Subject: Old Town Escape Barn Assessment Letter; Project No. 658052,  
Internal Order No. 24008534, Old Town

The Development Services Department has completed the Second review of the project referenced above, and described as:

Planned Development Permit and Conditional Use Permit for an escape room with two residences, located at 3886 Ampudia St. The 0.11-acre site is in the OTMCR-1-2 Zone, within the Old Town San Diego Community Plan area.

SHEET 6 of 11

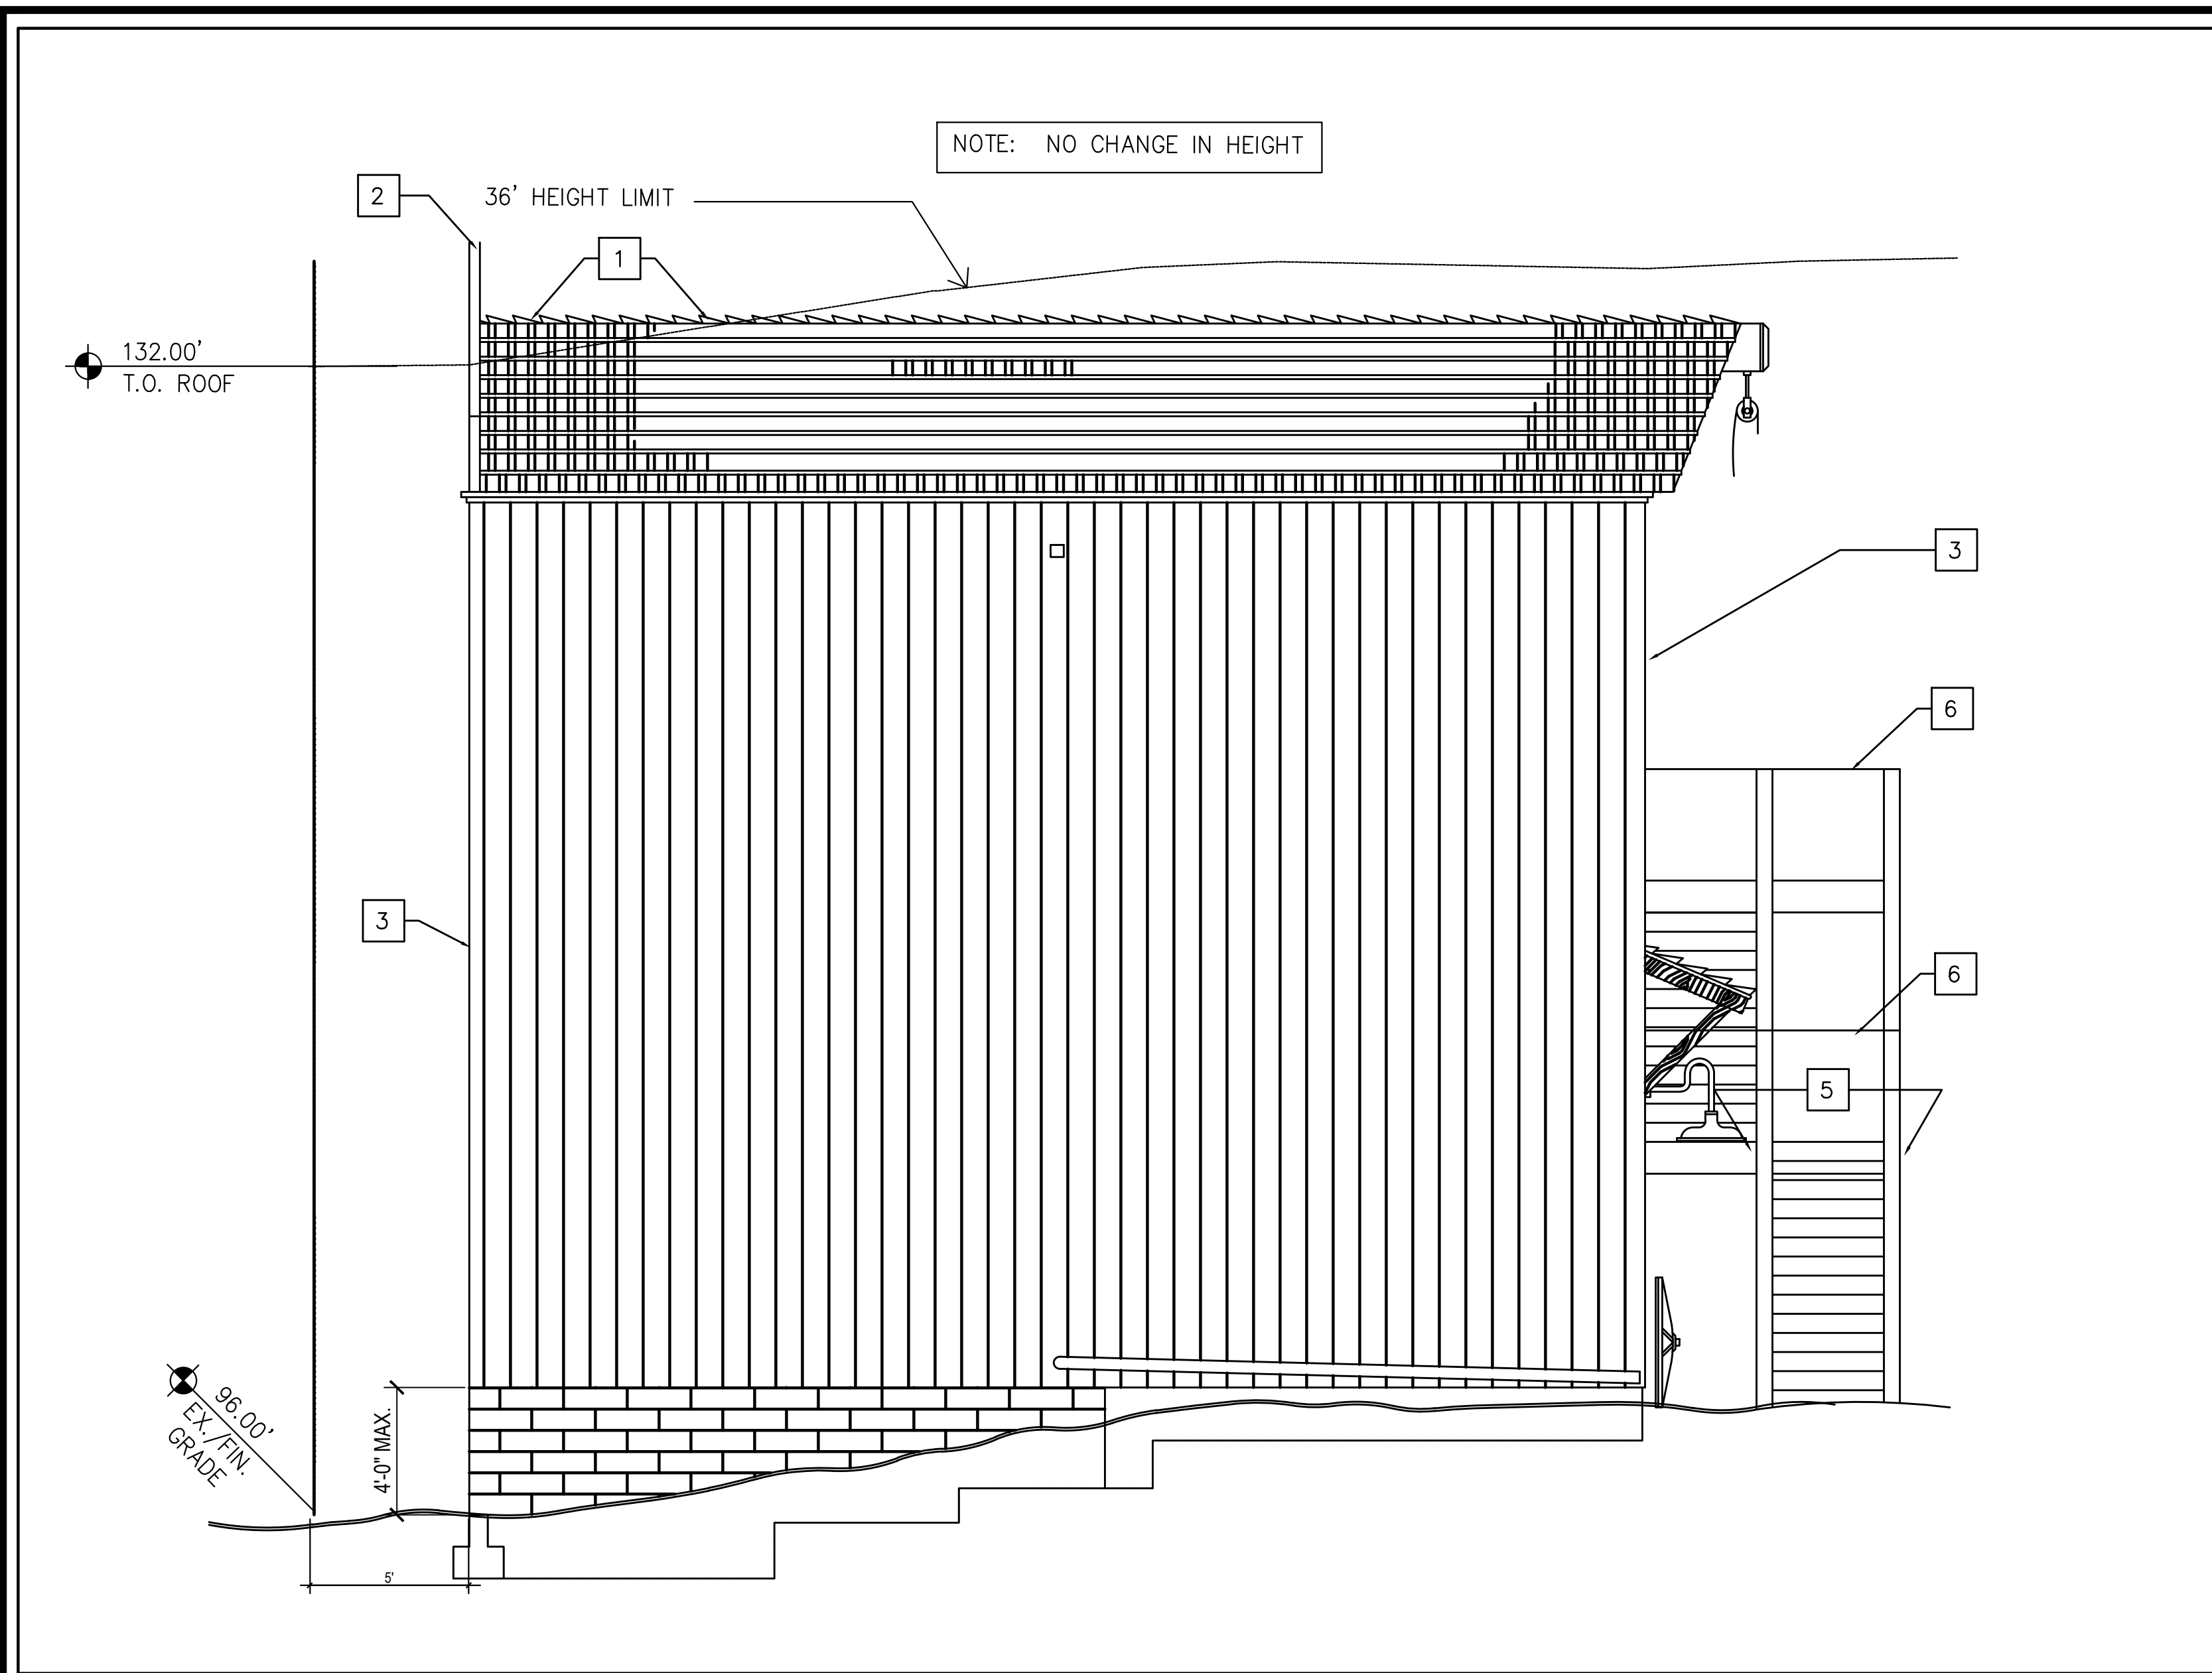
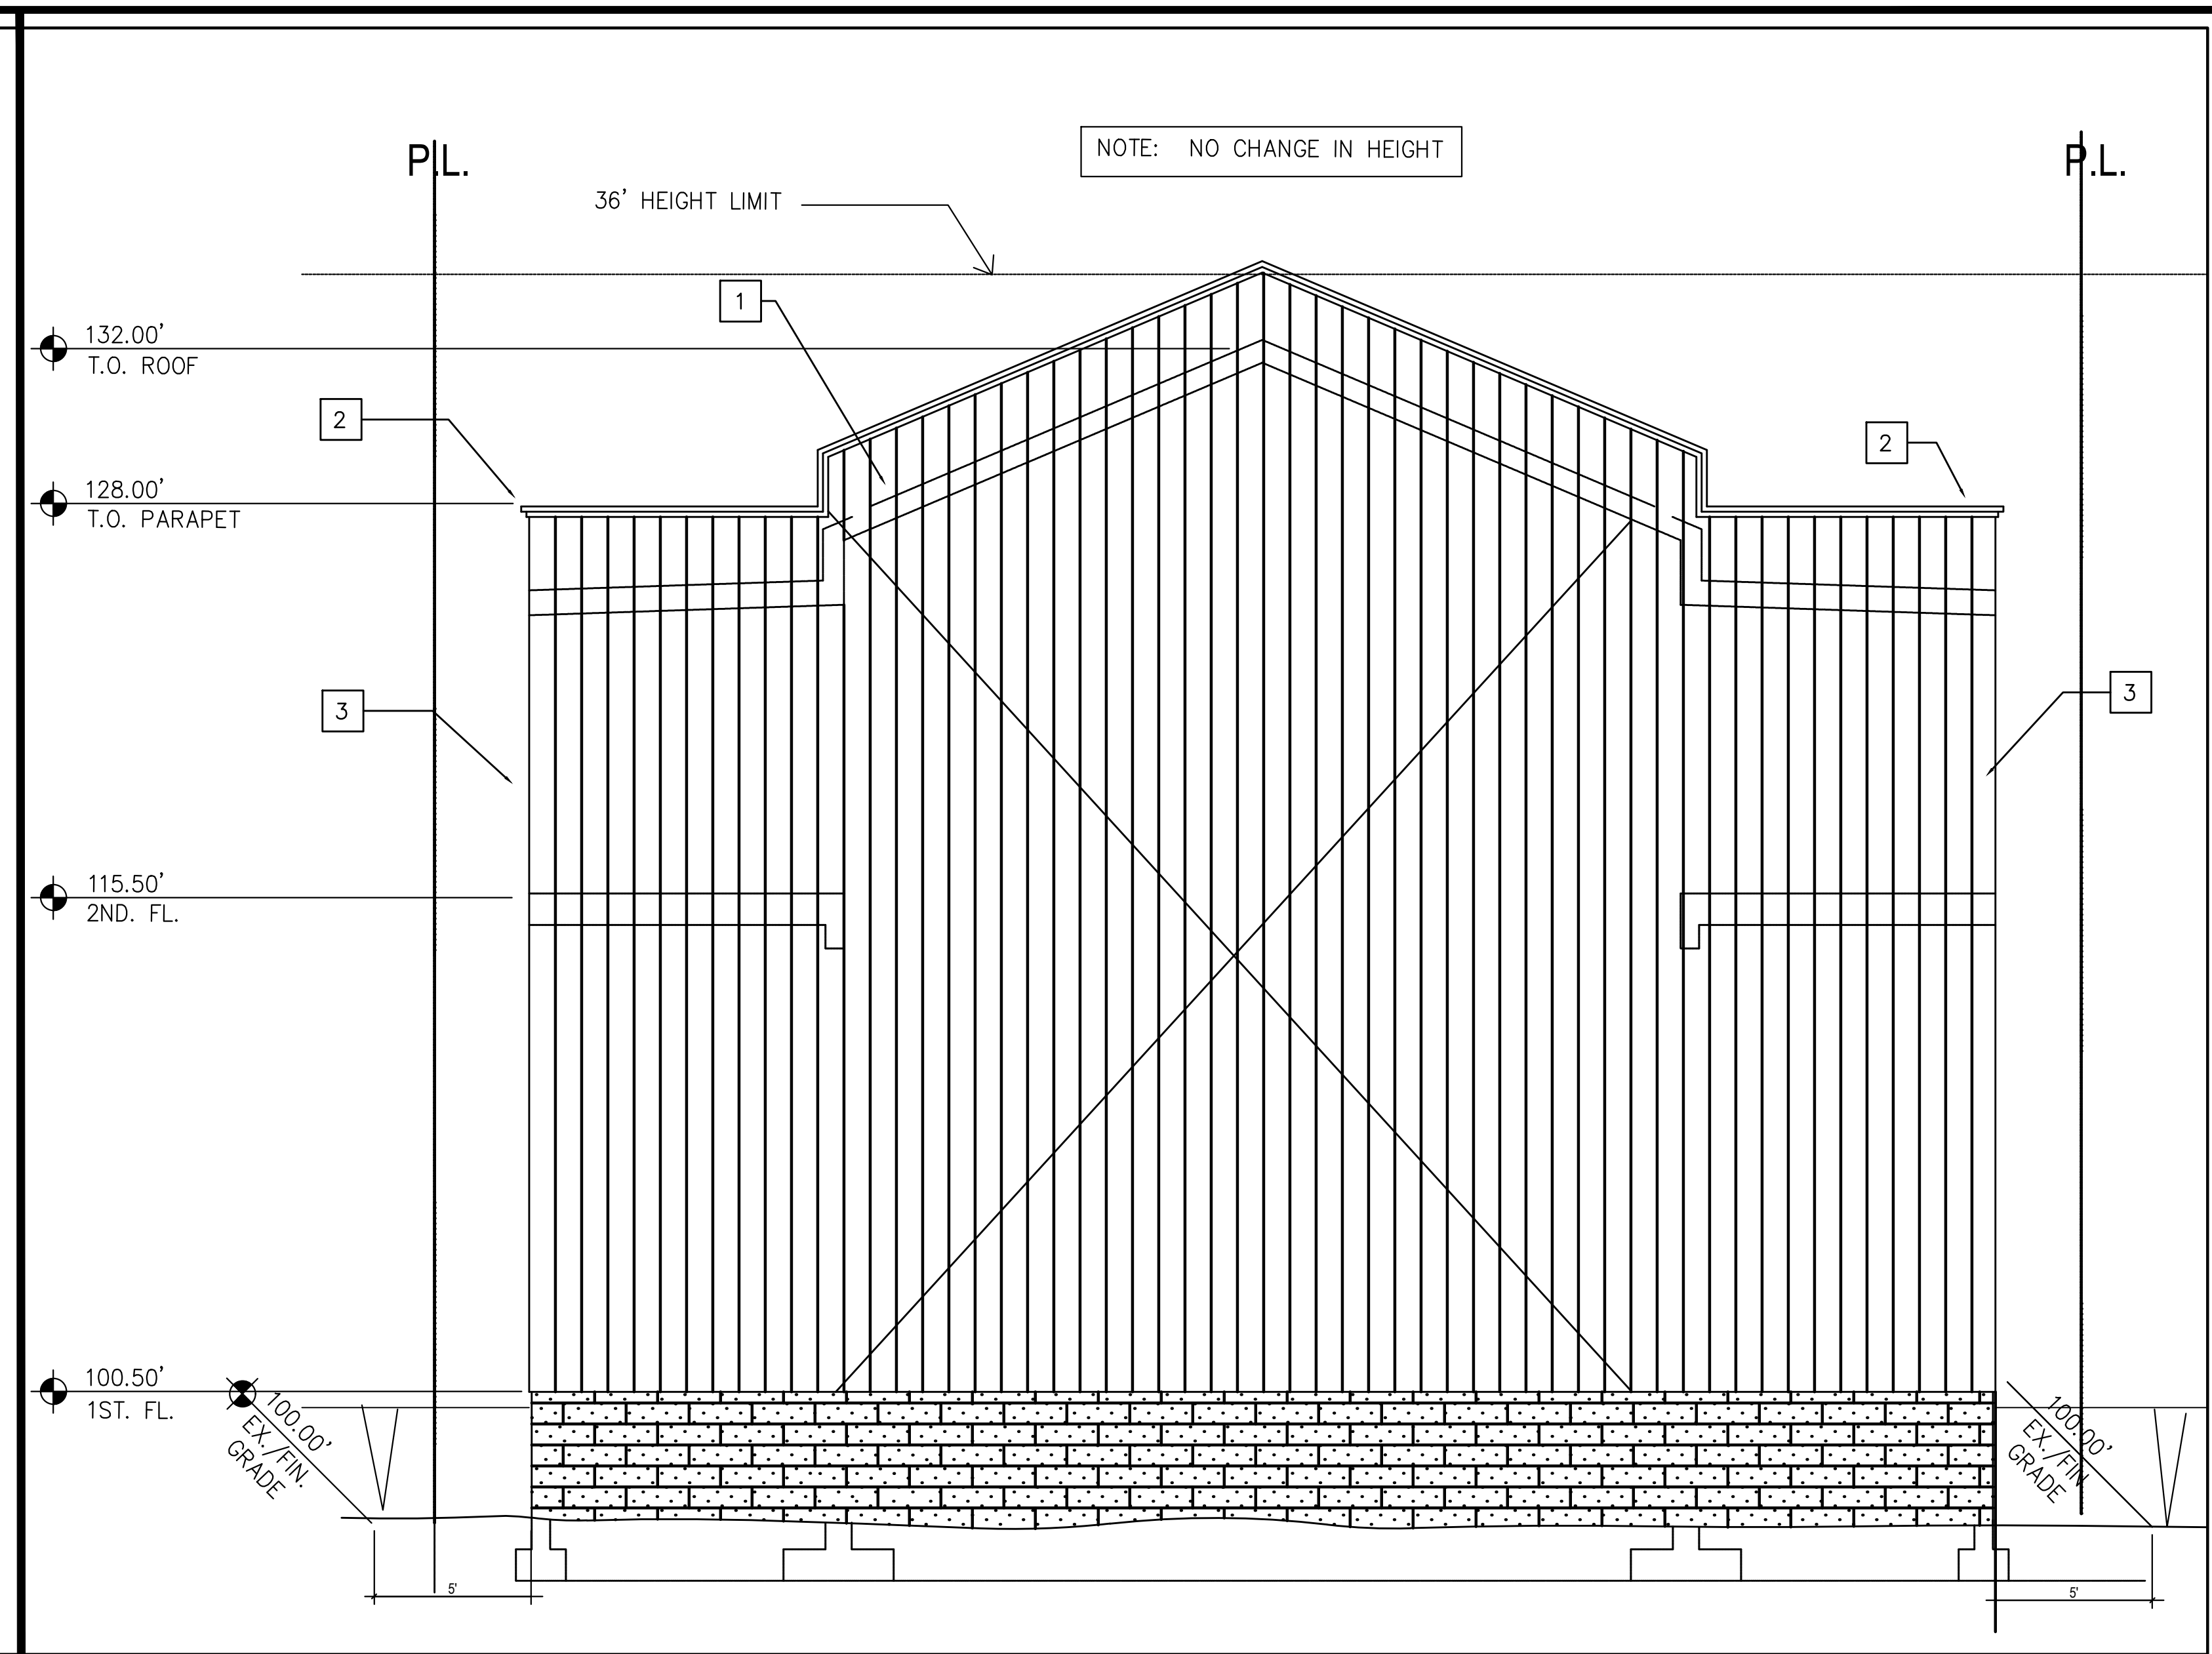
<u>Cleared?</u>	<u>Issue Num</u>	<u>Issue Text</u>
<input type="checkbox"/>	10	Please correct the Keynotes 9 and 10 on sheets 6 and 7; they are mislabeled. Keynote 9 states that the existing window to remain, but it is labeled on a door and Keynote 10 states existing door to remain, and it is labeled on a window. (From Cycle 2)
<input type="checkbox"/>	11	Please correct the sheet number within the note on Sheet 1 that states "Demolish and Reconstruct Parking Lot. See Sheet 9 for conceptual Landscape Plan". The Landscape Plan is on Sheet 11 (not Sheet 9) - the note needs to be corrected to reflect this change. (From Cycle 2)
